AGENDA
Special Hybrid Meeting
Town of Granby
Inland Wetlands and Watercourses Commission
Thursday, May 22, 2025, at 7:00 pm
Town Hall Meeting Room

MEETING MINUTES
Town of Granby
Inland Wetlands and Watercourses Commission
Wednesday, April 9, 2025, at 7:00 pm

GR-2

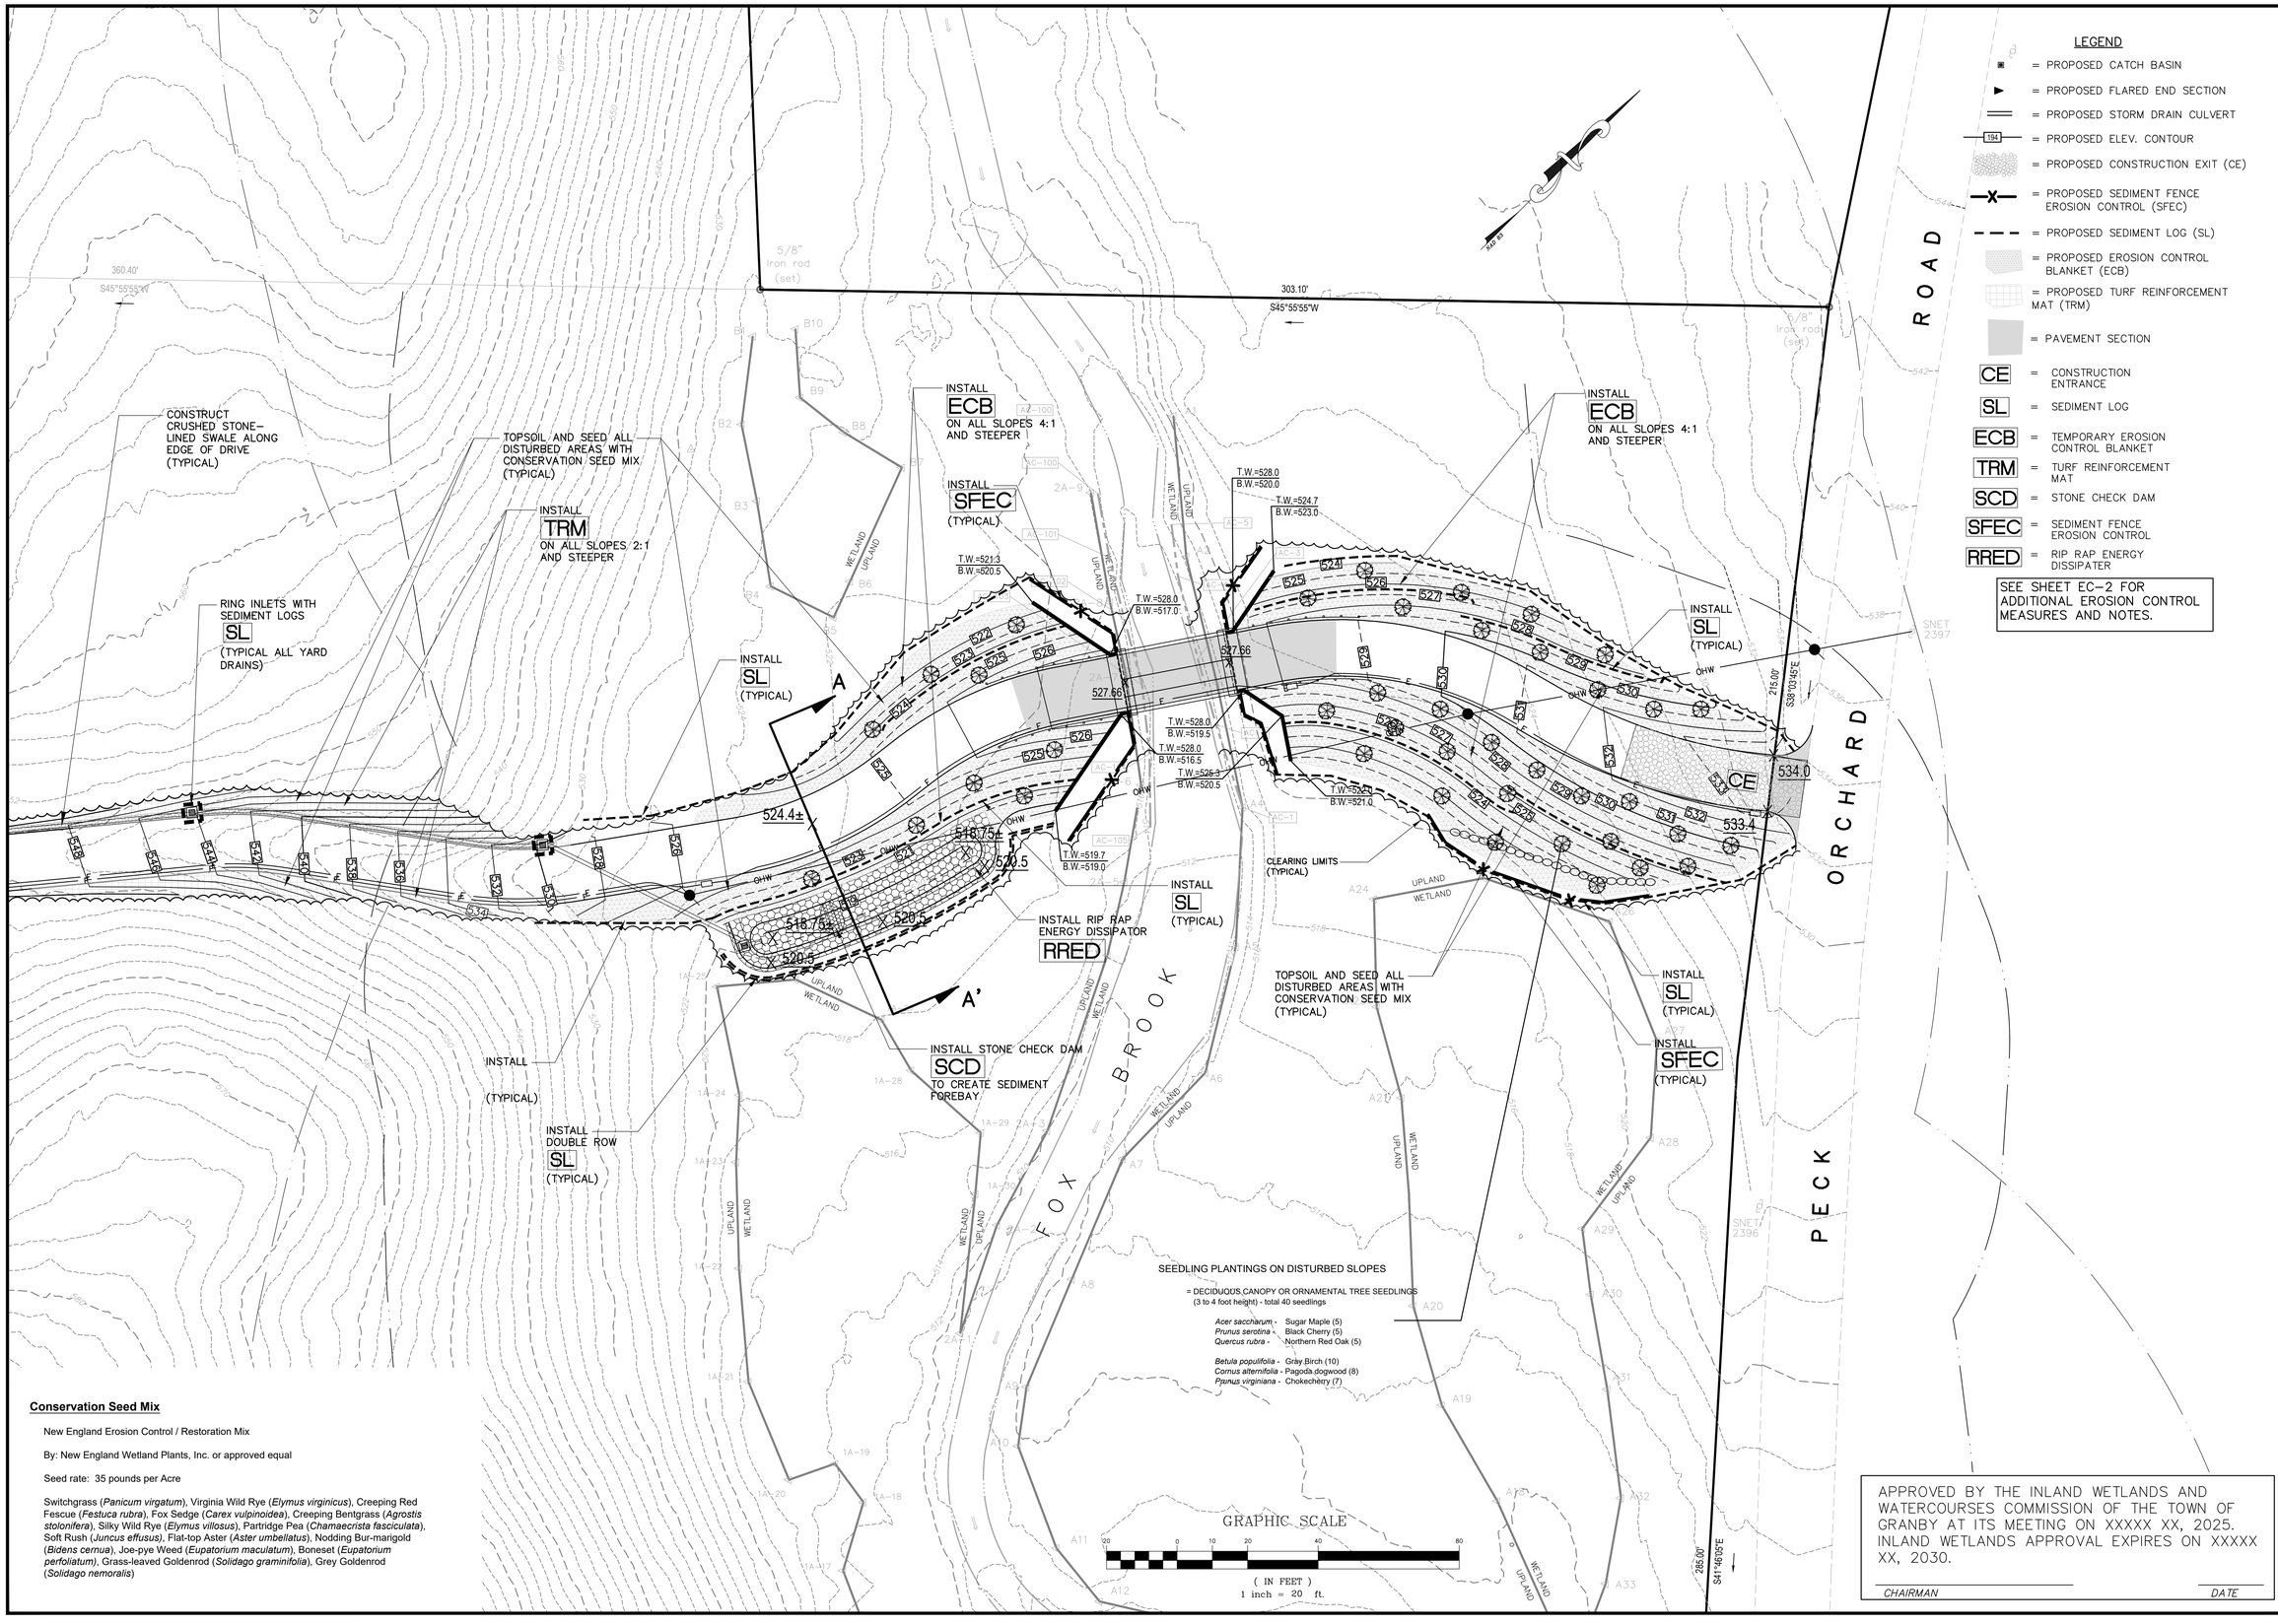
Sheet GR-1 &2

Plan Sheets GR-1 and GR-2 have been revised to show the location of utilities to be installed within the regulated areas. These include the installation of three utility poles and overhead electric and communications services. From the westernmost pole, utility service will continue underground to the house with electric in a three-inch conduit, communications in a two inch conduit. In addition, one spare three-inch conduit will be installed. Two 2-inch conduits will provide electric and communication services from the house back to Peck Orchard Road. These services will be for power and communication to security cameras and a possible future security gate.

EC-1

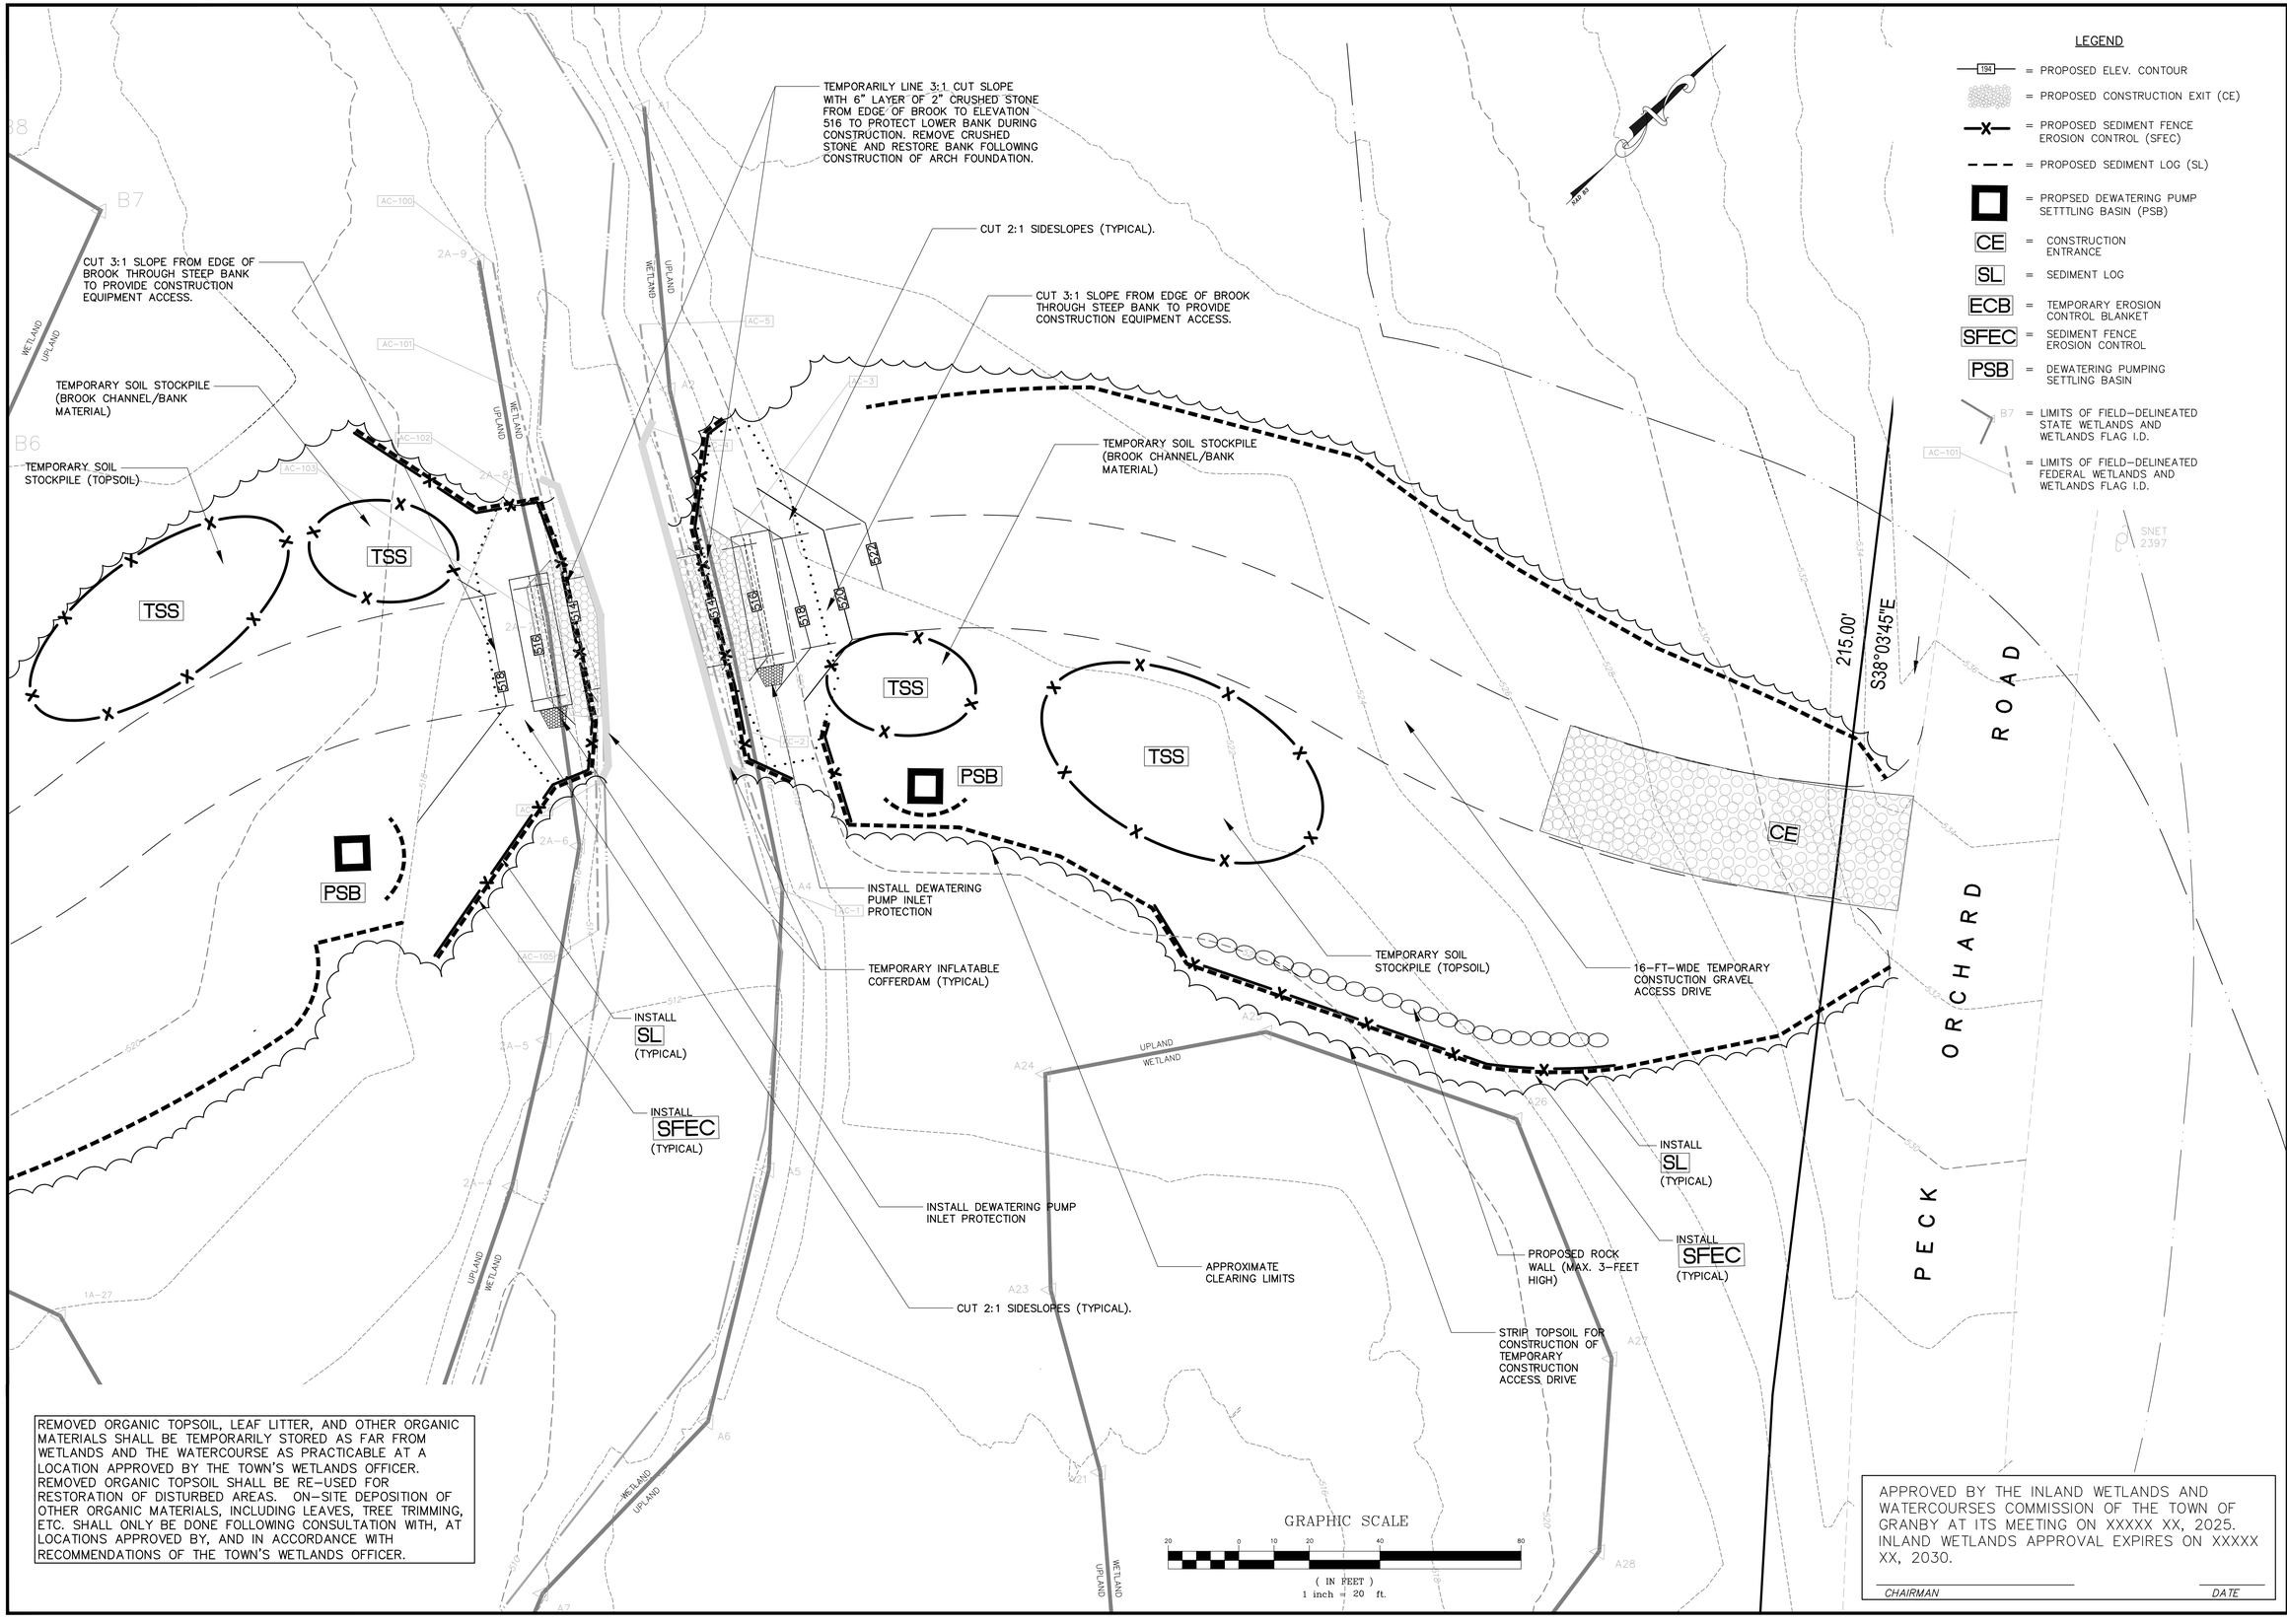
Sheet EC-1

2. Show CE dimensions as per the detail on Sheet SD-1. Modify width to fit.

The Construction Exit detail on Sheet SD-1, has been modified to show a 16-foot

width. The depiction of the CE on Sheet EC-1 and on Sheet EC-2 have been revised to show the 16'x50' size of the stone pad.
